PRODUCT/PROCESS CHANGE NOTICE (PCN)

ATTACHMENT 1 - PCN # : TB1601-01

PCN Type: Manufacturing Site - Alternate Test & Backend Location

Attachment 4 - Carrier Tape used by Sigurd

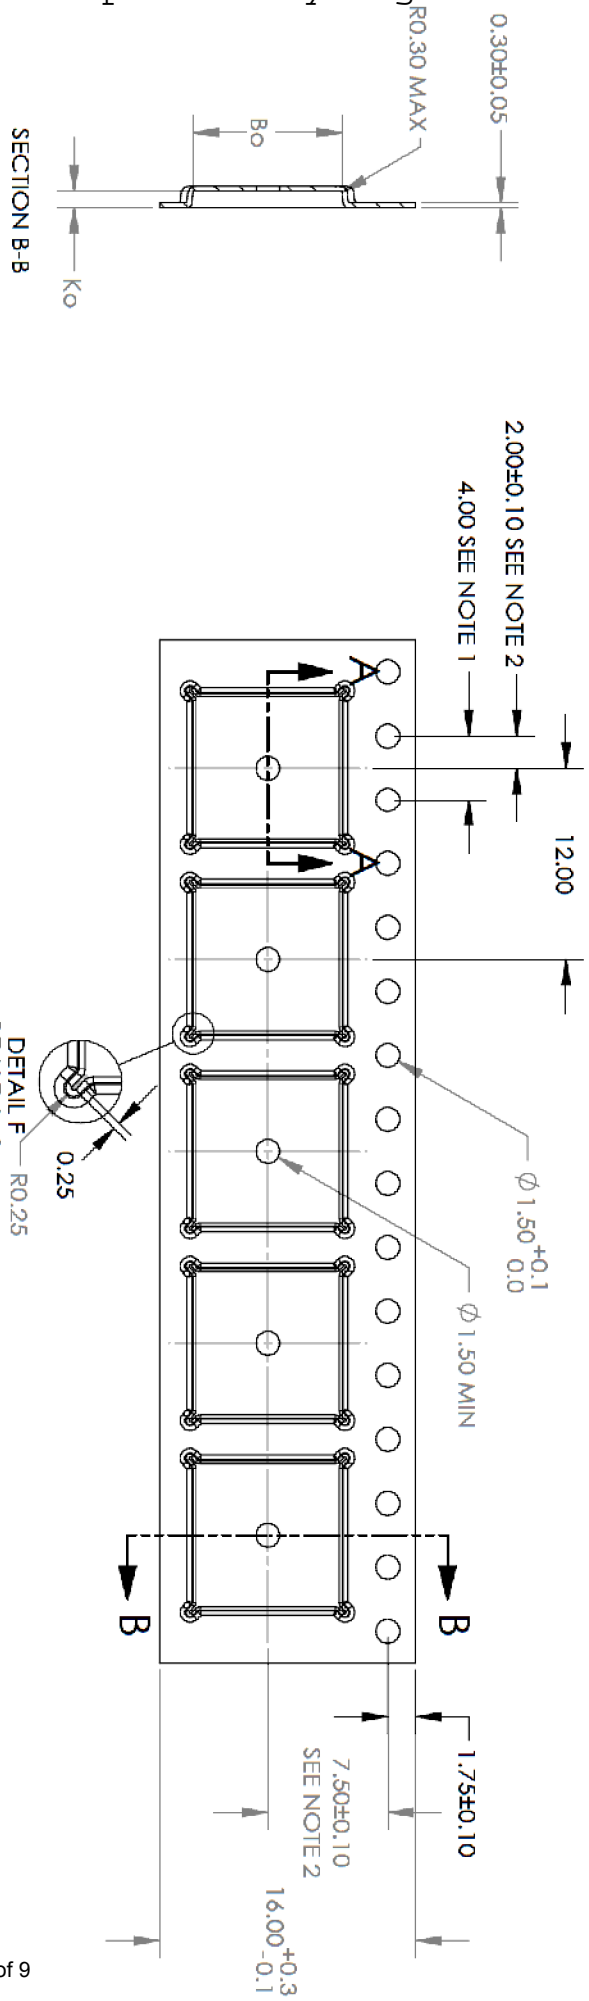
Item	Vendor	Carrier Dimensions		Cavity Dimensions (mm) ±0.1 or Specific				Top View	Drawing
		W (mm.) ±0.3	P1 (mm.) ±0.1	A0	B0	K0	K1		
IDT	PCT QFN9x9GP-20B3-360C-SD	16	12	9.3	9.3	1.05	NA		Refer Attachment 3
Sigurd	ADVANTEK ML0909-D	16	12	9.3	9.3	1.05	NA		Refer Attachment 4
